APPLICATION NO.	FILING DATE	FIRST NAMED INVENTOR	ATTORNEY DOCKET NO.	CONFIRMATION NO.
10/568,670	05/19/2006	Peter Schwarzler	GKNG 1278 PCT	2727
27256	7590	12/10/2008	EXAMINER	
Dickinson Wright PLLC 38525 Woodward Avenue Suite 2000 Bloomfield Hills, MI 48304			LOUDEN, CLIFFORD J	
			ART UNIT	PAPER NUMBER
			3679	
			MAIL DATE	DELIVERY MODE
			12/10/2008	PAPER

Office Action Summary	Application No. 10/568,670	Applicant(s) SCHWARZLER ET AL.	
	Examiner CLIFFORD J. LOUDEN	Art Unit 3679

DETAILED ACTION

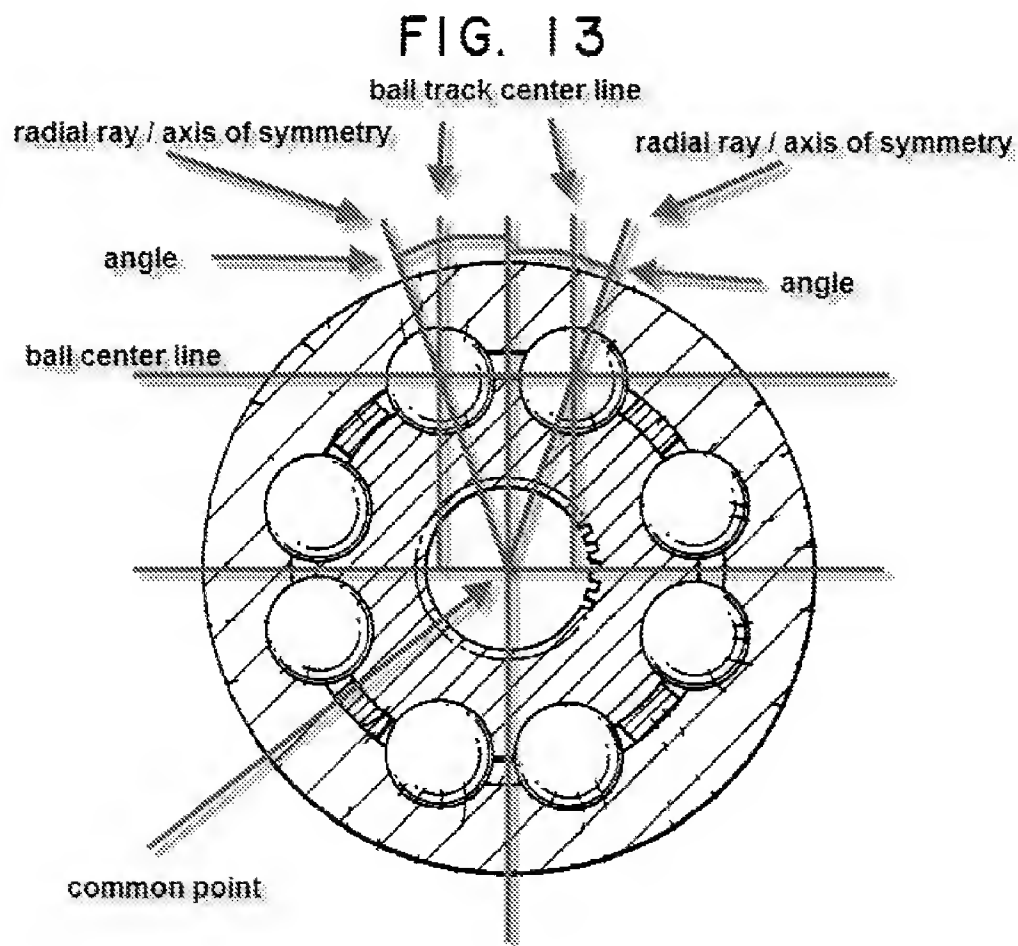
4. Claims 1, 14-15, 19-21 & 29 are rejected under 35 U.S.C. 102(b) as being anticipated by Ouchi et al., US 2001/0021671 (Ouchi). As to claim 1, Ouchi shows in Fig. 13 a constant velocity fixed joint (301d) comprising: an outer joint part (303B) having a longitudinal axis (directed into the figure), and an attaching end and an aperture end positioned axially opposite one another (inherent to constant velocity joints and exemplified in Fig. 5), and outer ball tracks (308); an inner joint part (302A) having a longitudinal axis (directed into the figure), an attaching mechanism for a shaft pointing towards the aperture end of the outer joint part (inherent to constant velocity joints and exemplified in Fig. 5), and inner ball tracks (307), the outer ball tracks and the inner ball tracks form pairs of tracks which each accommodate a torque transmitting ball, wherein each two adjoining pairs of tracks comprise outer ball tracks whose center lines are positioned in planes (shown in the examiner marked diagram below and labeled as “ball track center line”) which extend substantially parallel relative to one another, and inner ball tracks whose center lines are positioned in planes (shown in the examiner marked diagram below and labeled as “ball track center line”) which extend substantially parallel relative to one another; and an annular ball cage (309d) between the outer joint part and the inner joint part and comprising circumferentially distributed cage windows which each accommodate the torque transmitting balls of two of said adjoining pairs of tracks; wherein, in an aligned joint, centers (shown in the examiner marked diagram below and labeled as “ball center line”) of the balls are held by the ball cage in the joint center plane (inherent to constant velocity joints and exemplified in Fig. 6) and, when the joint is articulated, the ball centers are guided onto the

angle-bisecting plane (exemplified by Fig. 21) between the longitudinal axes, and wherein track cross-sections of the outer ball tracks and the inner ball tracks of each pair of tracks are symmetrical relative to axes of symmetry (shown in the examiner marked diagram below and labeled as “radial ray/axis of symmetry”) which, together with the outer and inner ball track planes, form identically sized angles (shown in the examiner marked diagram below and labeled as “angle”) opening in opposite directions, and each comprise a common point (shown in the examiner marked diagram below and labeled as “common point”).

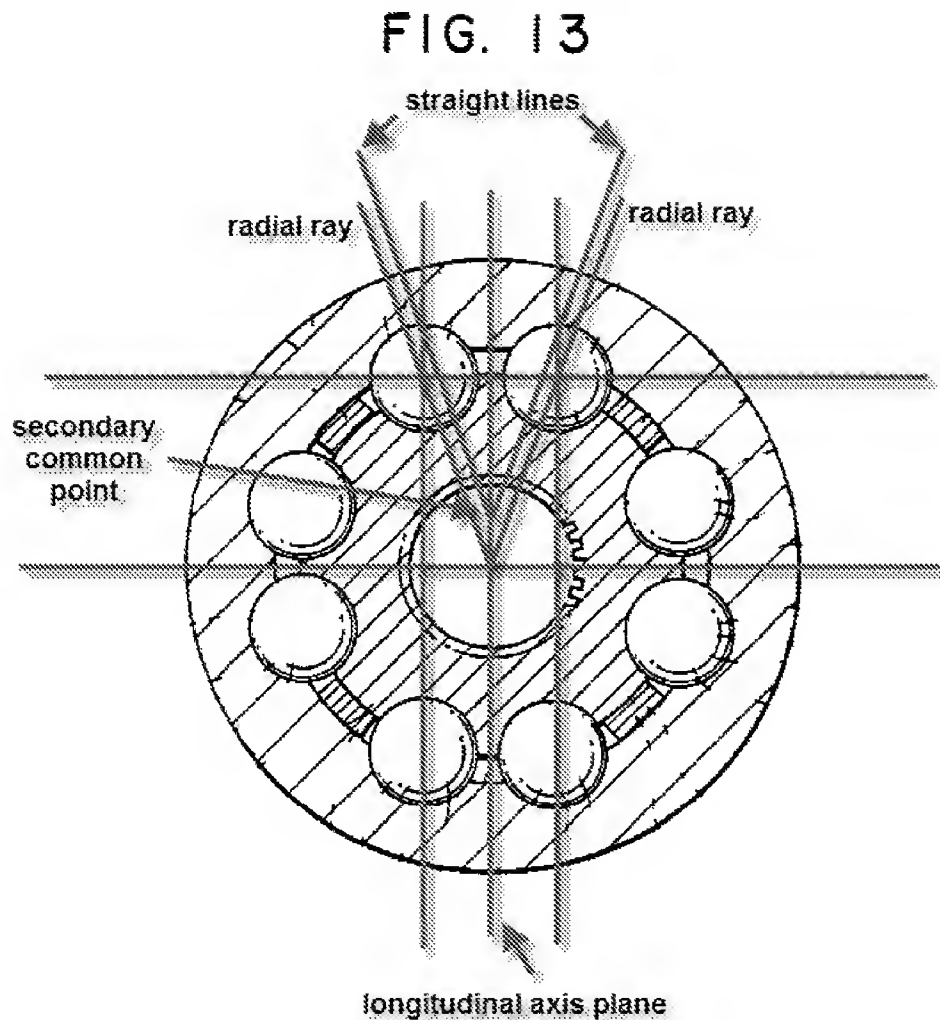
Claim 15: Ouchi shows the track cross-sections of the outer ball tracks and of the inner ball tracks of each pair of tracks are each symmetrical (about a line, running through the ball centers and perpendicular to the straight lines) relative to straight lines (shown in the examiner marked diagram below and labeled as “straight lines”) which are positioned in a cross-sectional plane and which extend parallel to radial rays (shown in the examiner marked diagram below and labeled as “radial ray”) from the longitudinal axes through the ball centers of the torque transmitting balls of the pair of tracks and which intersect one another in a common point (shown in the examiner marked diagram below and labeled as “secondary common point”) at a distance from the longitudinal axes.

Claims 19-21: Ouchi shows the track center lines of the outer ball tracks and of the inner ball tracks are positioned in planes (shown in the first examiner marked diagram above and labeled as “ball track center line”) which extend parallel relative to one another and parallel relative to the longitudinal axes of the joint and which extend through the ball centers of the balls of two of said adjoining pairs of tracks.

FIG. 6

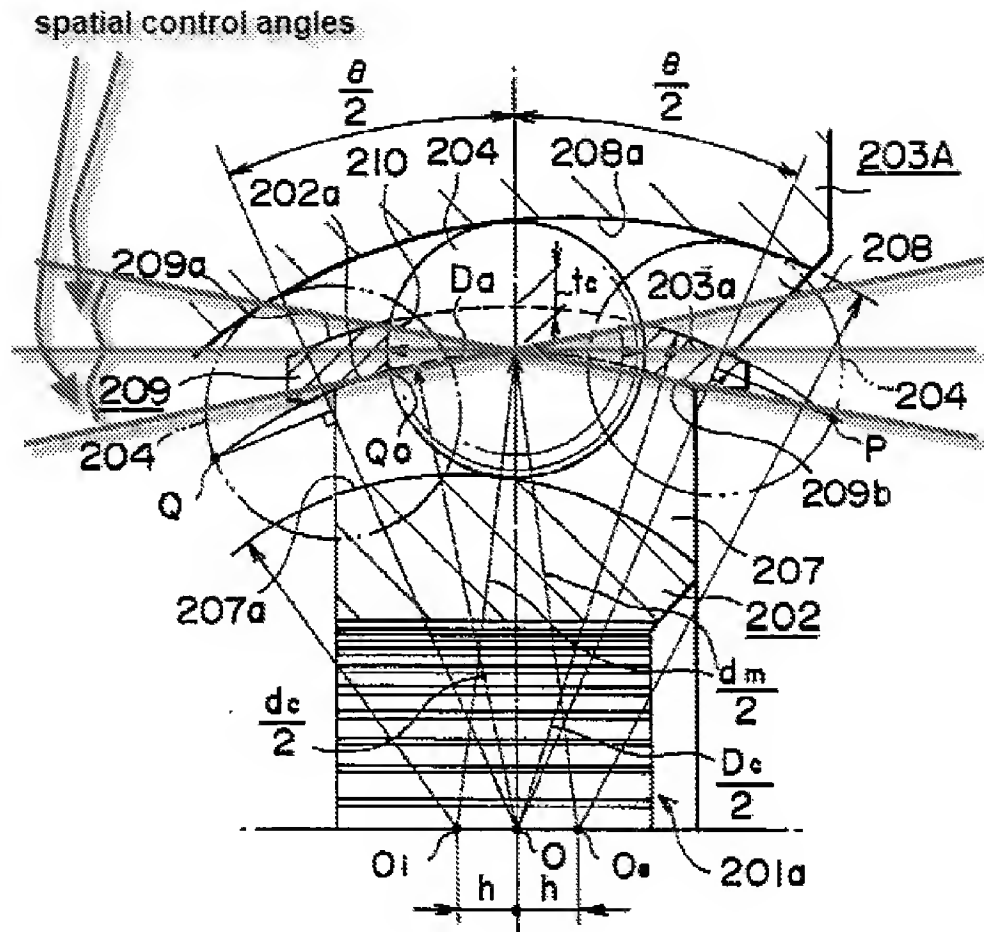
As to claim 27, Ouchi does not expressly disclose the angles of intersection (γ_0, γ_0') are selected in such a way that spatial control angles (ϵ_0, ϵ_0') of the pairs of tracks at the balls have the same value irrespective of whether the load turns clockwise or anti-clockwise. However, it appears that the angles of intersection selected (i.e. 0 degrees) were selected in such a way that the spatial control angles (as exemplified in the examiner marked diagram below and labeled as "spatial control angles") of the pairs of tracks at the balls have the same value irrespective of whether the load turns clockwise or anti-clockwise.
